REMARKS

AMENDMENTS TO THE DRAWINGS

Annotated Drawing Sheet Showing Proposed Changes

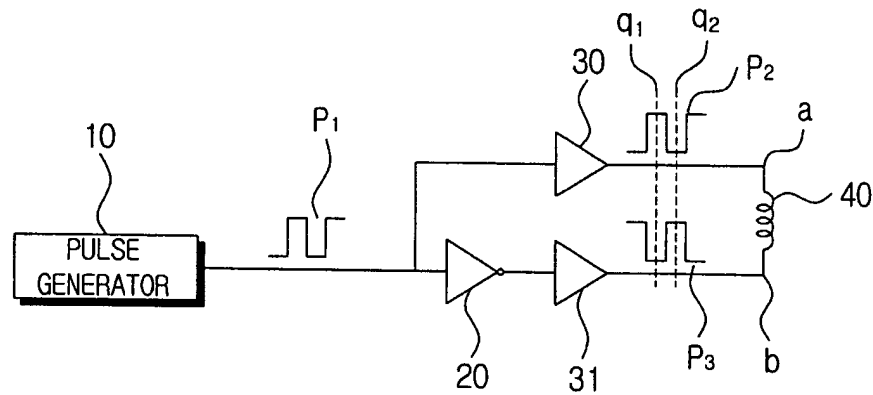
In the outstanding Office action, the Examiner objected to the drawing figures. In particular, the Examiner objected to FIG. 1 for failing to include the legend "PRIOR ART" and to FIG. 2 for being unclear.

The Examiner further indicated that the interconnection between FIGS. 2, 3 and 4 is unclear. Applicants respectfully submit that the instant amendment to FIG. 2 clarifies the relationship between FIGS. 2, 3 and 4.

**FIG. 1**  
 (PRIOR ART) ← **KINDLY ADD**

By the instant amendment, addition of a legend "PRIOR ART" has been proposed in FIG. 1 and addition of a previously omitted element, viz., AND gate 160, has been proposed in FIG. 2. No new matter has been added to the instant amendment to FIG. 2 as the relationship between the pulse controller 110, the pulse generator 120, and the AND gate 160 is illustrated in FIG. 4 as originally filed.

The attached sheets of drawings include proposed changes to FIGS. 1 and 2. The attached drawing sheet of FIGS. 1 and 2 replaces the original drawing sheet of FIGS. 1 and 2. In FIG. 1, addition of a legend "PRIOR ART" has been proposed. In FIG. 2, addition of a previously omitted element, viz., AND gate 160, and deletion of some aspects have been proposed. No new matter has been added to the instant amendment to FIG. 2 as the relationship between the pulse controller 110, the pulse generator 120, and the AND gate 160 is illustrated in FIG. 4 as originally filed.
